# Access Compliance Report

## Public Rights-of-Way

### (Curb Ramps)

Intersection ID: 30054	Main Street: DAY_LILLY_LN	Cross Street: SOUTHWIND_DR	Location: S
ADA ID: 67776BF7403A	Ramp Type: PerpDiag	Initial Pass/Fail: Fail	Overall Compliance: No
Severity Score: 10			
Codes/Mitigation Info/Possible Solution		Field Measurements/Component Compliance

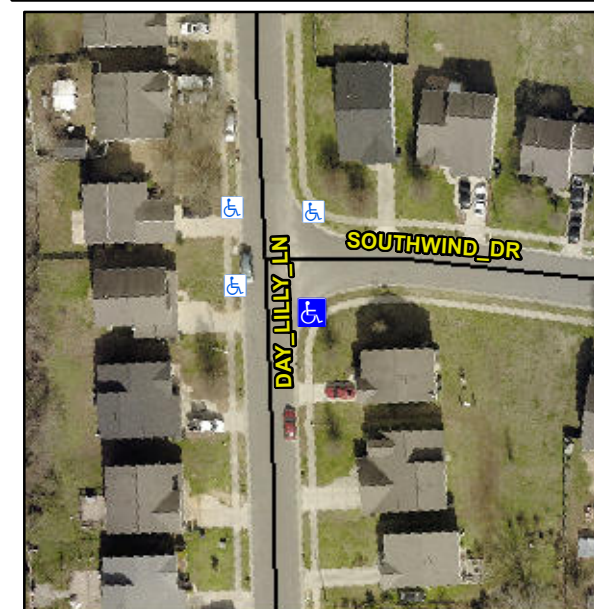
**Not Found, R304.5.1, R304.5.3**

Compliance	Description	Data	Compliance	Description	Data
N/A	Ramp Length (in)	51.0	Yes	Ramp Slope (%)	6.1
No	Ramp Width (in)	42.0	No	Ramp XSlope (%)	2.5
N/A	Flare Type LT	N/A	N/A	Flare Type RT	N/A
N/A	Flare Slope LT (%)	N/A	N/A	Flare Slope RT (%)	N/A
N/A	Flare Traversable LT?	N/A	N/A	Flare Traversable RT?	N/A
N/A	Landing Length (in)	N/A	N/A	DWS Provided?	N/A
N/A	Landing Width (in)	N/A	N/A	DWS Contrast?	N/A
N/A	Landing Slope (%)	N/A	N/A	DWS Length (in)	N/A
N/A	Landing X Slope (%)	N/A	N/A	DWS Full Width?	N/A
N/A	Landing Curb? (Y/N)	N/A	N/A	DWS Offset (in)	N/A
N/A	Shared Landing?	N/A			
N/A	Gutter Ponding?	N/A	N/A	Gutter Slope (%)	N/A
N/A	Gutter Lip Ht (in)	N/A	N/A	Gutter X Slope (%)	N/A
N/A	Painted X Walk1?	No	N/A	Painted X Walk2?	No
	X Walk 1 Direction	To N		X Walk 2 Direction	To NW
N/A	X Walk 1 Width (in)	N/A	N/A	X Walk 2 Width (in)	N/A
	X Walk 1 Slope (%)	0.0		X Walk 2 Slope (%)	1.4
	X Walk 1 X Slope (%)	2.8		X Walk 2 X Slope (%)	2.2

**Remove & Replace Curb Ramp With Two New Directional Ramps or Equivalent.**
